Amendments to the Drawings:

REMARKS

FIG. 3b

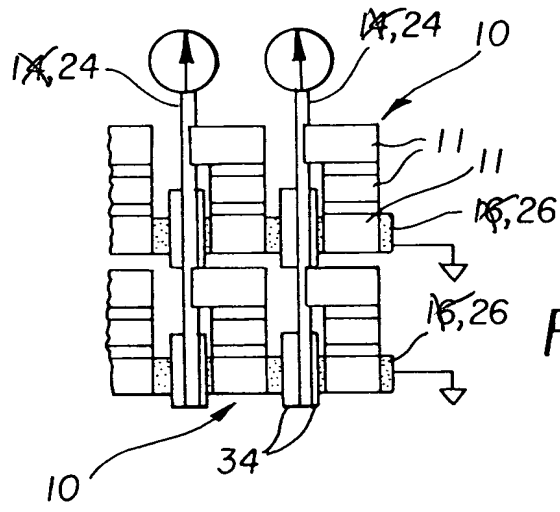
Replacement sheets for FIGS. 1-8 are enclosed which formalize the drawings that were submitted with the application. The enclosed sheets of drawings include changes to FIGS. 3b, 4b, 5b and 6b in which elements 14 and 16 have been removed. No other changes have been made and these drawings are believed to satisfy the objections raised by the Examiner. Approval by the Examiner is respectfully requested.
